Post Public Consultation Report

Transport Infrastructure Ireland

January 2025

N7 JUNCTION 4 CROSSING POINT

Figure 3-1 - Indicative Sketch of preferred option

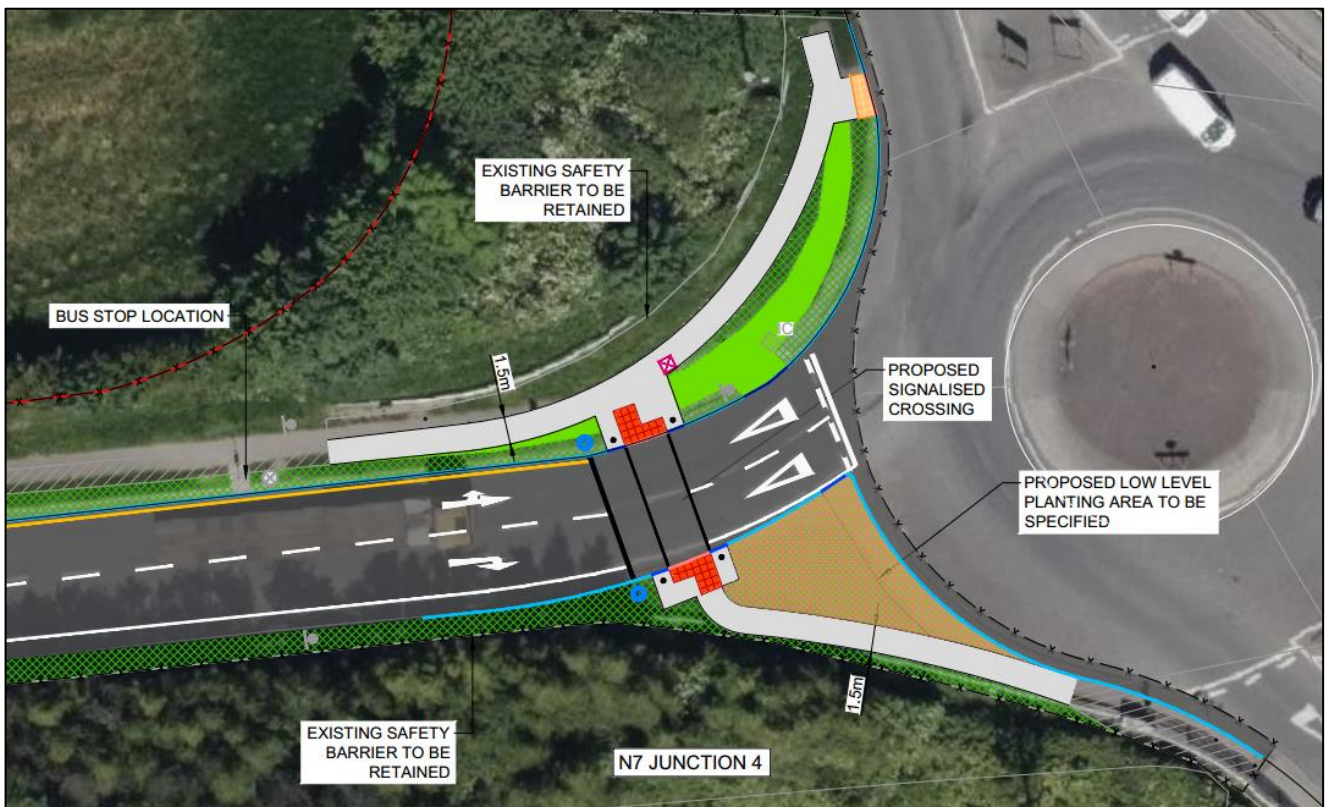
Issue	Description	Count	Percentage of responses	Response
Safety Issues regarding crossing on northern arm	Request to consider the safety of individuals using the northern arm crossing point by adding an additional crossing.	2	100%	<p>The proposed pedestrian crossing at N7 Junction 4 Eastbound Off Ramp will link Rathcoole and Saggart villages with the N7 Eastbound Rathcoole Bus Stop. The scheme aims to address pedestrian safety concerns and allow pedestrians to cross the N7 Junction 4 Eastbound Slip safely towards the bus stop.</p> <p>A comprehensive review of pedestrian and cyclist accessibility throughout the entire junction(N& J4), including the northern arm is planned to ensure that the needs of pedestrians at all key points are fully addressed and will be a subsequent piece of work for the junction. Due to timing constraints, the provision on the off slip is proposed to take place first with other work to take place after this and following the larger study of the entire junction.</p>

Submission No	Author	Submission	Response
SD-C343-1	Member of the public	<i>"I think there should be one more crossing for people coming from the bus stop or Rathcoole village to cross main street which i marked with red spot on the screenshot bellow, its really hard to cross here, especially in the morning when all the cars are coming from the roundabout to grenogue business park on full gas."</i>	<p>The proposed pedestrian crossing at N7 Junction 4 Eastbound Off Ramp will link Rathcoole and Saggart villages with the N7 Eastbound Rathcoole Bus Stop. The scheme aims to address pedestrian safety concerns and allow pedestrians to cross the N7 Junction 4 Eastbound Slip safely towards the bus stop.</p> <p>A comprehensive review of pedestrian and cyclist accessibility throughout the entire junction, including the northern arm is planned to ensure that the needs of pedestrians at all key points are fully addressed and will be a subsequent piece of work for the junction. Due to timing constraints, the provision on the off slip is proposed to take place first with other work to take place after this and following the larger study of the junction.</p>

SD-C343-2	Member of the public	<i>"As mentioned in an earlier objection[submission], there needs to be an additional crossing as per attached image. The proposed crossing covers only half of the needs for pedestrians trying to cross in all directions. The new footpath beside the bus stop, ends nowhere as there is no footpath to continue walking. Please rethink and propose alternative as per our objections."</i>	Please refer to the response to submission 1 above.

Both of the proposed changes raised by members of the public that have been noted in this report have been reviewed. There are no changes made to the proposed design after reviewing the additional changes proposed by the public through the South Dublin County Council’s Public Consultation Portal. These will be studied for implementation in the subsequent larger study.
